SUBJECT: STAFF OBSERVATIONS OF TESTING FOR GENERIC
SAFETY ISSUE 191 DURING MARCH 8 AND MARCH 9
TRIP TO THE ALION HYDRAULICS LABORATORY

AT ALION SCIENCE AND TECHNOLOGY HYDRAULICS LABORATORY

MARCH 8 AND 9, 2007

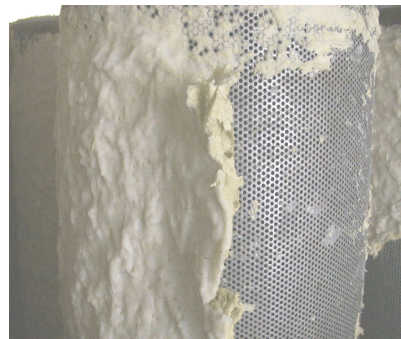
- The configuration of the wooden enclosure around the strainers may have resulted in preferential loading of the front two top hats/modules and more likely the front surfaces of these two top hats. Based upon previous staff experience, this may have been a small effect for this test and may even be typical of loading of the outside strainers in the plant. However, this effect should be considered in the design of the test protocol.
